Vol 1	Current Schedule/Appendix	Proposed Amendment	Rationale
Volume 1 Schedule C		<p>Add proposed road identifier (as per the legend) to extend Upper Sherman Ave to to urban boundary.</p>	<p>An extension of Upper Sherman Avenue was approved through Draft Approved Subdivision Applications (25T94005 & 25T95002), but has not been constructed yet. As such, this new extension to the road requires an amendment to identify the “proposed road”.</p>
Volume 1 Schedule E-1	<p>Schedule E-1 designates subject lands (located at star identifier) as neighbourhoods</p> 	<p>Revise Schedule “E-1” to redesignate lands in from neighbourhoods to institutional</p> <p>Waterdown North Secondary Plan Map B.4.2-1 designates subject lands (located at star identifiers) as Institutional</p> 	<p>An amendment is required for consistent implementation.</p> <p>The former Flamborough OP secondary plan designated the area as “major institutional”. In addition, the lands have a combined area of over 4 hectares, which is consistent with institutional policy E.6.2.1.</p>

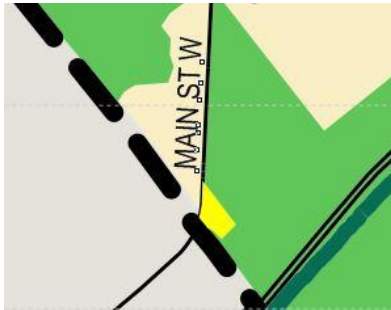
Volume 1 Schedule E-1	<p>Schedule E-1 designates lands at Nos. 1967-2003 as Open Space</p> 	<p>Revise Schedule E-1 to redesignate lands from Open Space to neighbourhoods. for the lands(marked in yellow) located between Nos. 1967 and 2003 Main Street West (Hamilton).</p> 	<p>An amendment is required to reflect the current land uses. These lands are occupied by various forms of residential dwellings. They were inadvertently added to the Open Space designation of the cemetery which was at the rear of the properties.</p> <p>The majority of the lands have residential zoning.</p>

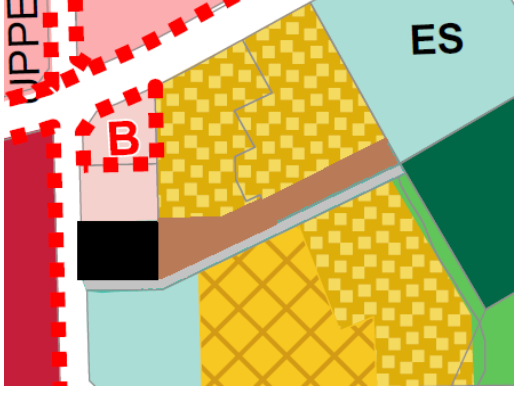
Vol 2	Current Map/Appendix	Proposed Amendment	Rationale
<p>West Waterdown Secondary Plan</p>	<p>Map B.4.1-1</p> 	<p>Remove area circled in red from “General Open Space” designation as its current use is residential, not park. The land was purchased by the owners of 76 Commando Court.</p>	<p>Subdivision agreement (1992) noted that Flamborough didn’t require piece of land for park purposes. As such, Block 45 was sold by developer to private land owner. Therefore, an amendment is required to recognize the existing residential use by redesignating the lands from open space to residential.</p> <p>The subject lands (being redesignated to residential through this Housekeeping Amendment) will be included in the upcoming Hamilton Zoning By-law 05-200 residential zoning project to rezone the land from the existing “O2” zone to a residential zone.</p>
